January 9, 2023

Linda Jackson,  
Payette Forest Supervisor  
Stibnite Gold Project  
500 N. Mission Street, Building 2, McCall, Idaho 83638  
Portal (<https://cara.fs2c.usda.gov/Public/CommentInput?Project=50516>)

Re: Comments on the Stibnite Gold Project Supplemental Draft Environmental Impact Statement

Figure 1 - Map of millsite claims

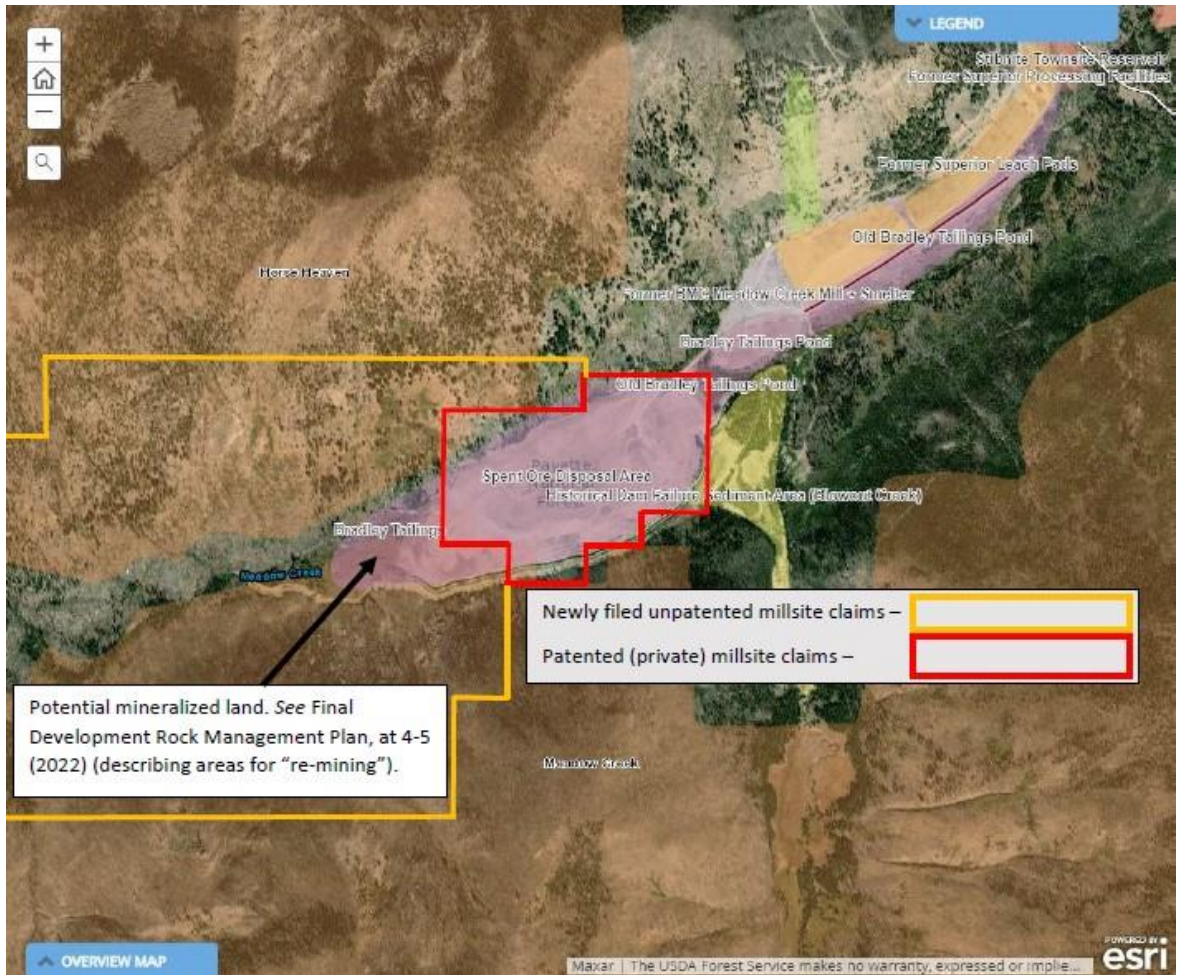
Commenters have provided the following map to illustrate where these new millsite claims are located in relation to historic and proposed mining claims and features. *See* Figure 1 and 2 below. Under the United States mining laws, millsite claims associated with a “vein or lode” must be located on “nonmineral land not contiguous to the vein or lode” and may not exceed five acres in size. 30 U.S.C. § 42(a). Additionally, the number of millsites a claimant can locate may be dependent upon the number of “associated” mining claims that meet the patenting requirements to ensure a one-to-one ratio between the two types of claims. Accordingly, if there are 188 unpatented mill site claims that were located and filed with BLM on September 1, 2022, there should also be 188 unpatented lode claims that meet the requirements necessary for patent, i.e., the claims must be valid because a discovery has occurred within the boundaries of the claim. *See* 30 U.S.C. §§ 26 and 29; *see also United States v. Cameron*, 252 U.S. 450, 460 (1920) (“All must conform to the law under which [mining claim patents] are initiated; otherwise they work an unlawful private appropriation in derogation of the rights of the public.”). Because it appears that the mineral resources proposed to be mined for the SGP are located almost entirely on private lands, it is unclear whether there are 188 valid unpatented mining claims associated with the mineral resource. *See* Brown & Caldwell, Final Development Rock Management Plan 1-4 (May 2022) (depicting location of mineral resources at the proposed SGP mine site). Indeed, the SDEIS provides no documentation regarding specific mining claim locations and validity thereof nor has the Forest Service responded to requests for such documentation of specific claim locations and validity thereof.

It also appears that at least 15 of the new millsite claims are located on top of an area that is proposed to be “re-mined” under the 2021 MMP. *See* Figure 1 and 2 below. *See also* Brown & Caldwell, Final Development Rock Management 4-5 (May 2022) (describing “plans to re-mine and reprocess the Bradley tailings deposited in the Meadow Creek Valley located within the planned footprint of the proposed TSF. . . . Other legacy materials that constitute tailings from pre-Bradley milling operations are likely present and commingled

Because the plan to “re-mine” this area indicates the presence of mineralized land beneath the 15 (and perhaps more) millsite claims, the mill sites do not qualify as “nonmineral land” under the United States mining laws. Millsites identified as potentially being over-filed on land that is not “nonmineral” are: TSF-A-157; TSF-A-144; TSF-A-126; TSF-A-125; TSF-A-124; TSF-A-123; TSF-D-1; TSF-D-2; TSF-D-3; TSF-D-4; TSF-C-1; TSF-C-2; TSF-C-3; TSF-C-4; TSF-B-2. **This list is not exhaustive.** Depending on the extent of “re-mining” that occurs in this area, other millsite claims may overlay mineralized land. In any event, the Forest Service must determine whether the millsites are valid. *These comments also incorporate by reference the map depicting locations of the newly filed unpatented mill site claims in relation to other mine site features—which is similar to maps in Figures 1 and 2 below—that is included on page 12 of the comments from the Nez Perce Tribe.*

In sum, the Forest Service must verify the validity of each unpatented lode and millsite claim within the operations boundary as well as along the proposed Burntlog Route where operations authorized by the United States mining laws are proposed to occur — whether or not the proposed operations’ use and occupancy of those claims is temporary or permanent.
